Re:- Plot no 26/5 J. m. 3
Jamsheer Quarters.

NOTICE OF COMPLETION UNDER SECTION 187 (1) OF THE
CITY OF KARACHI MUNICIPAL ACT, 1933.

AMENDED
PLAN SHOWING ADDITIONS & ALTERATIONS IN
BUNGALOW ON PLOT NO. 26/5 J.M.3 SEHWANI
CO-OPERATIVE HOUSING SOCIETY
JAMSHED Q² SCALE 8=1

Diary sheet in respect of Building Regulation plans received.

AMENDED
PLAN SHOWING ADDITIONS & ALTERATIONS IN

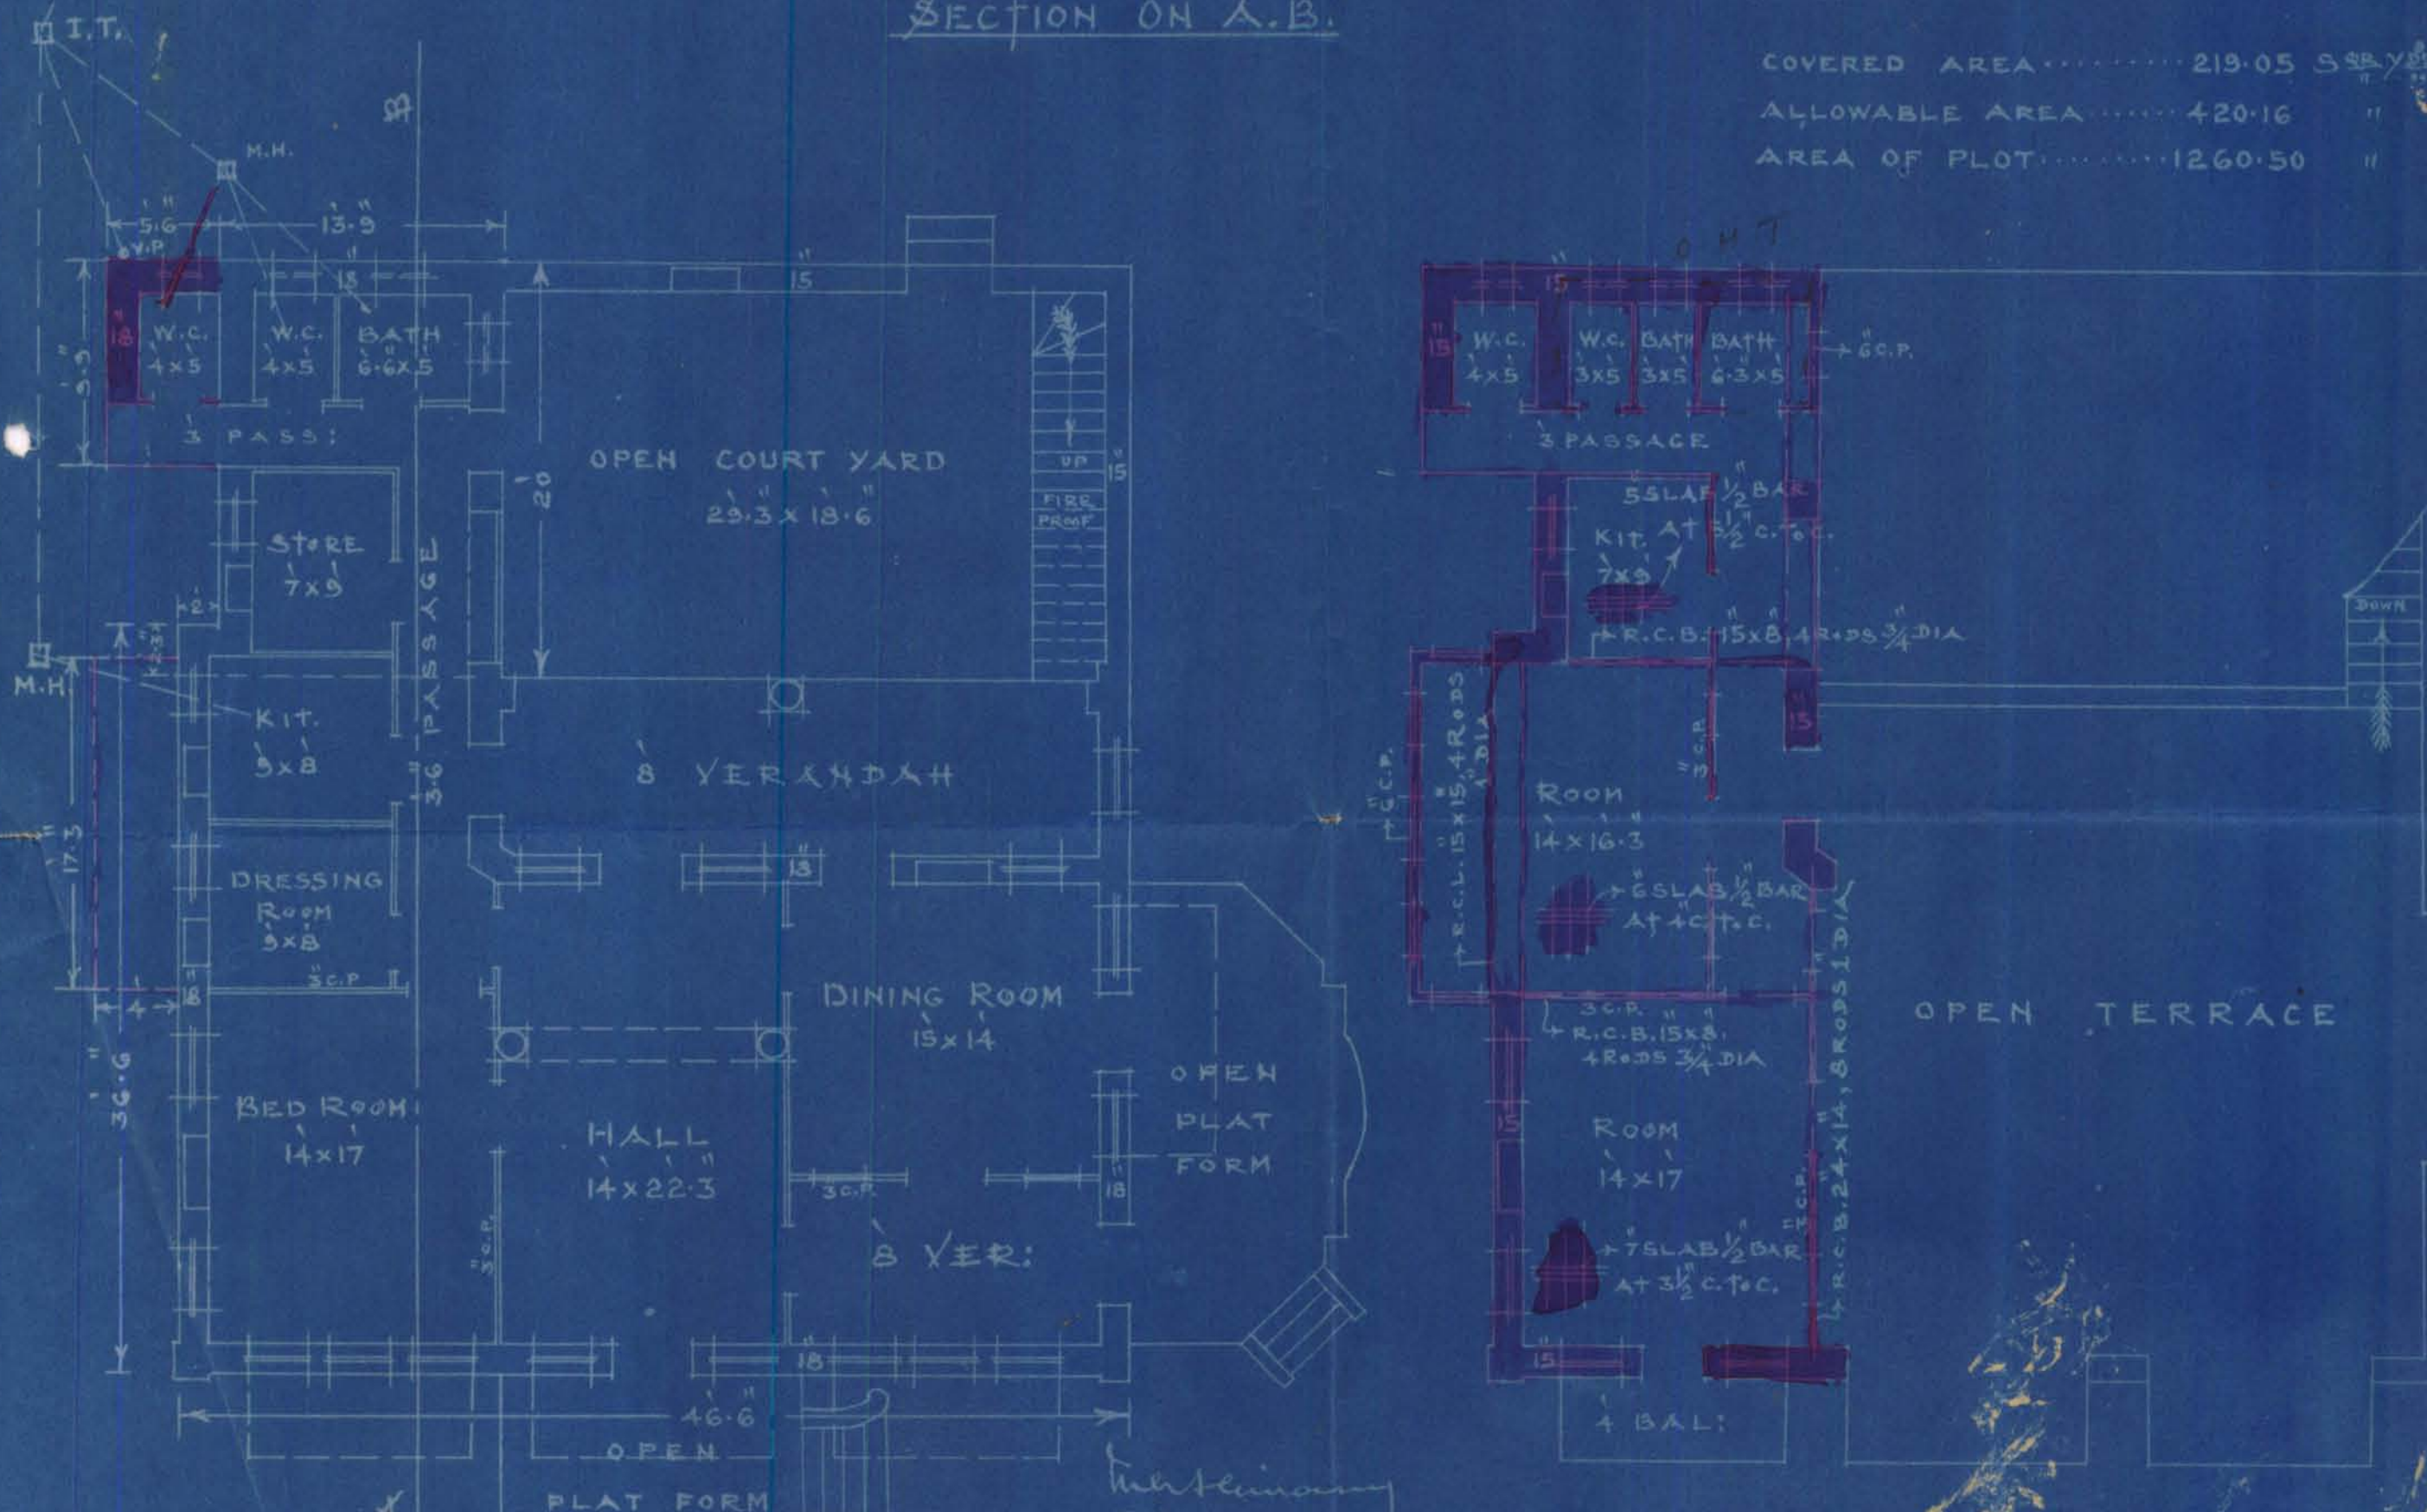
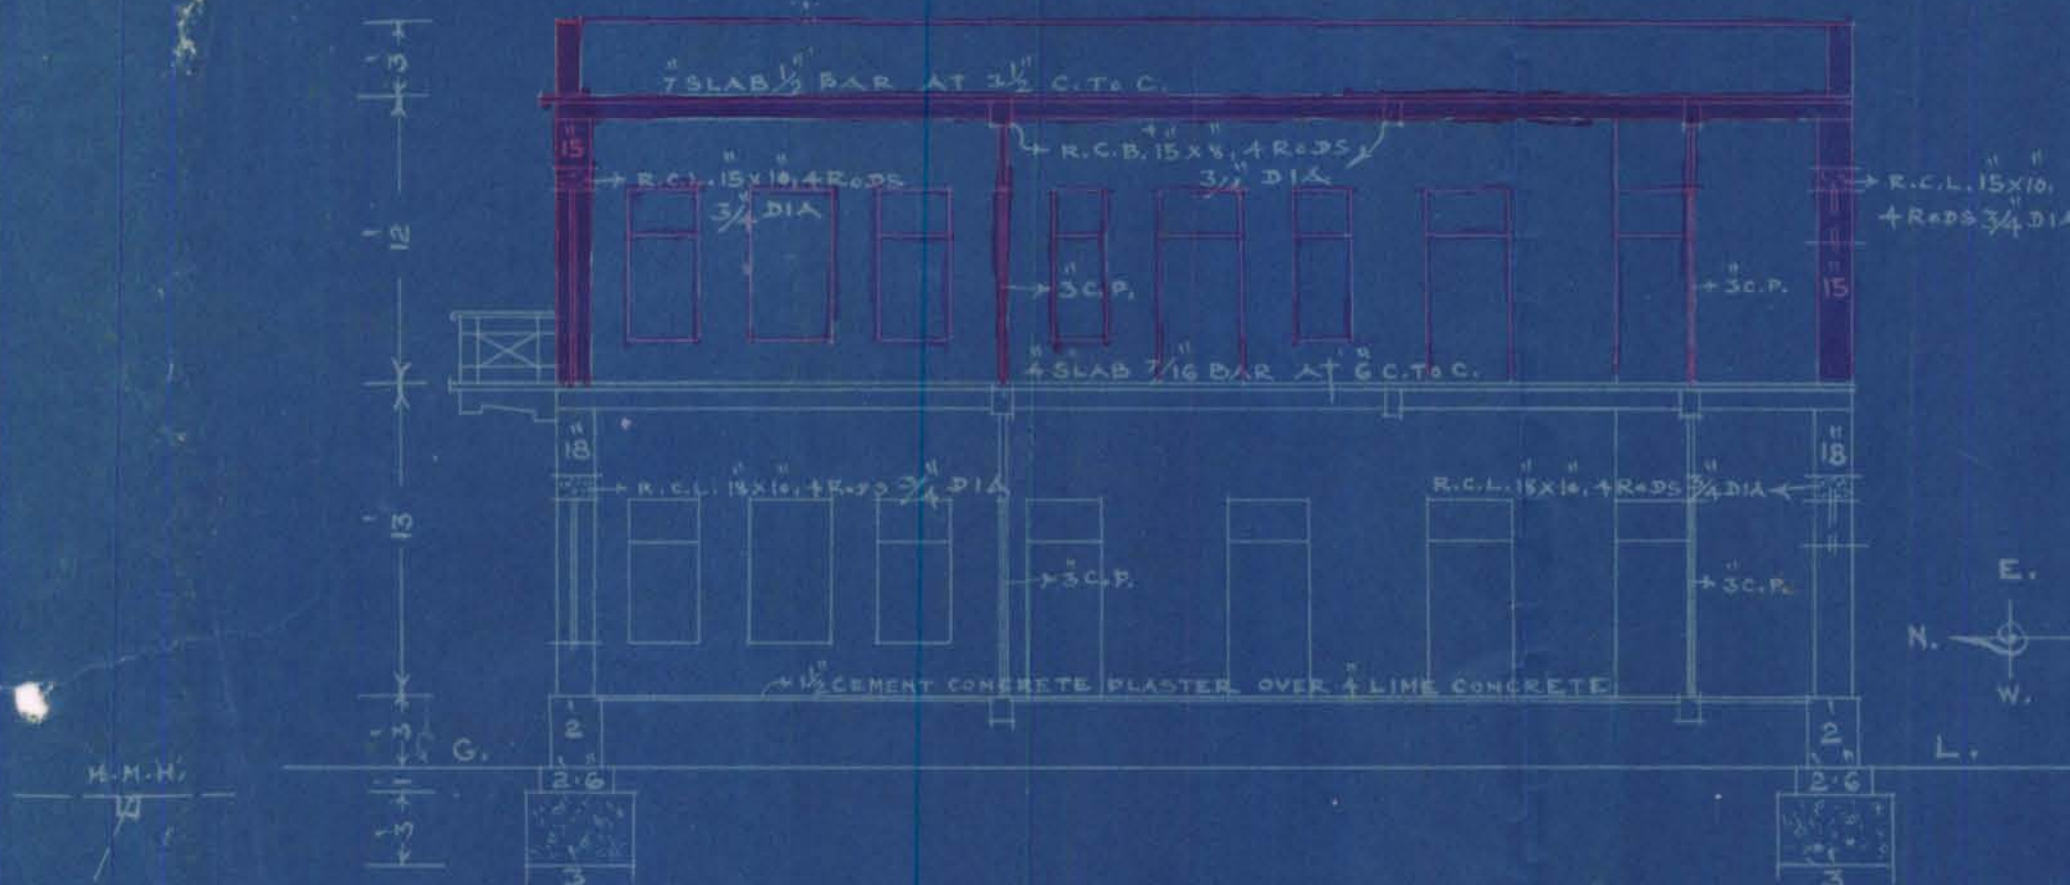
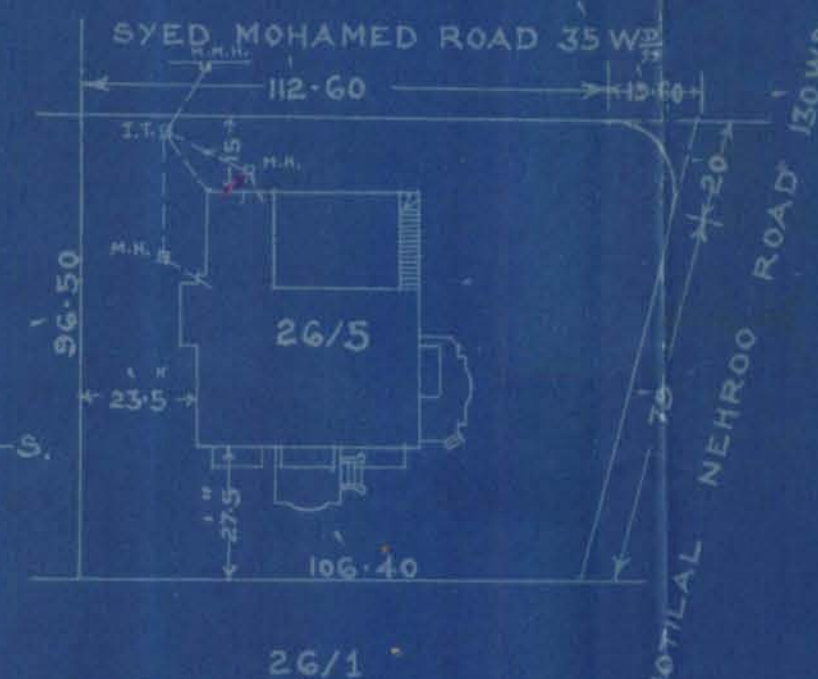
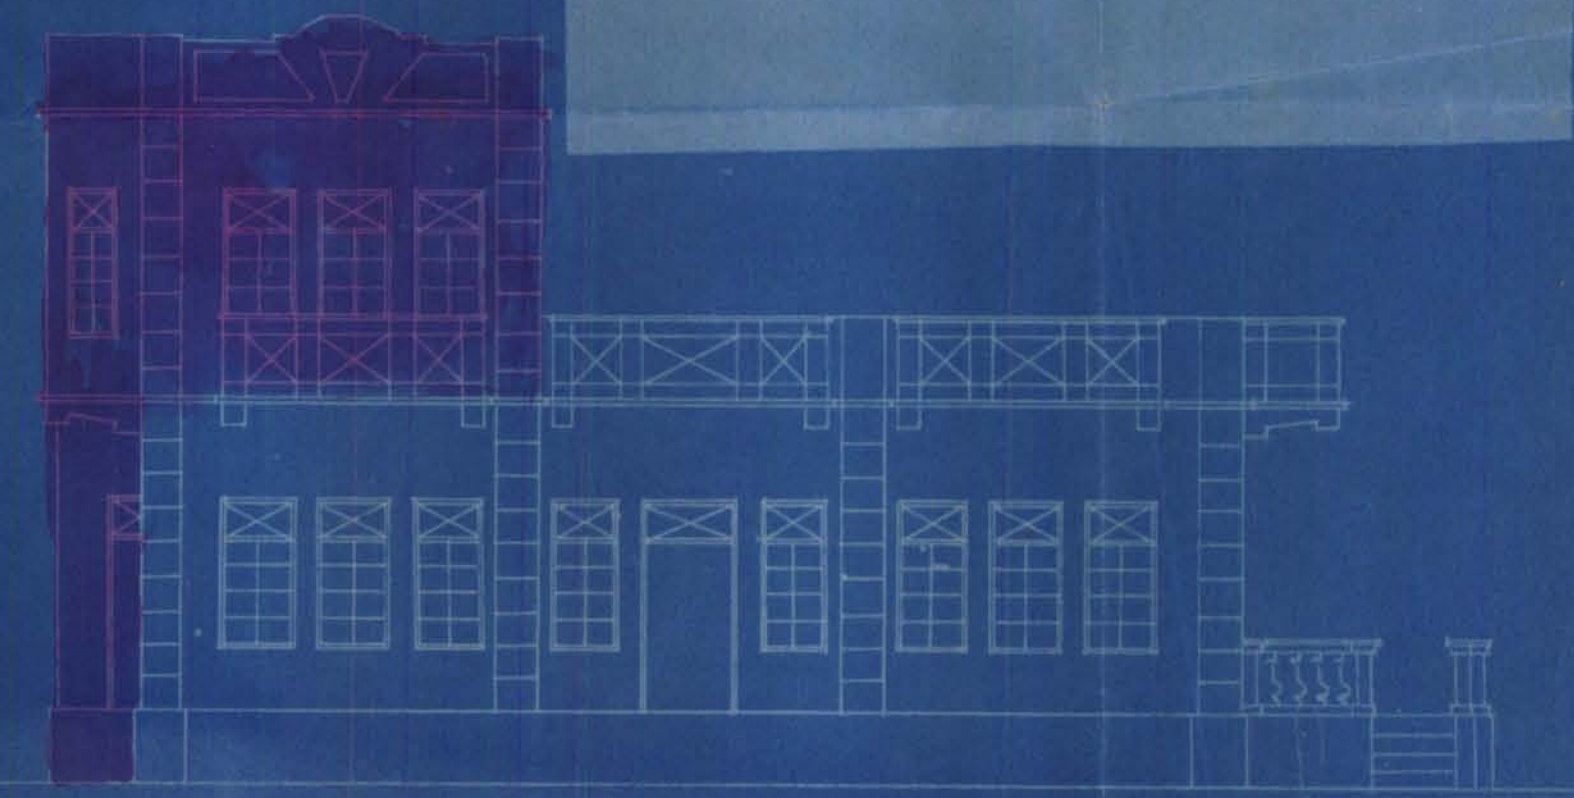
- (1) There is discrepancy in the built up area measurement and calculations.
- (2) Arrangements for joint measurement and verification of the built up area to be made.
- (3) In the site plan outline of the building is not correctly drawn.

1. There is discrepancy in the built up area measurement and calculations
2. Arrangements for joint measurement and verification of the built up area to be made
3. In the site-plan outline of the building it is not correctly drawn 26/x

With reference to your letter no L.C.C
366/39 dated 3rd instant I have to submit
the plans duly corrected.

1. This is correct.
2. I think this is as per municipal record.
3. This is also correct.
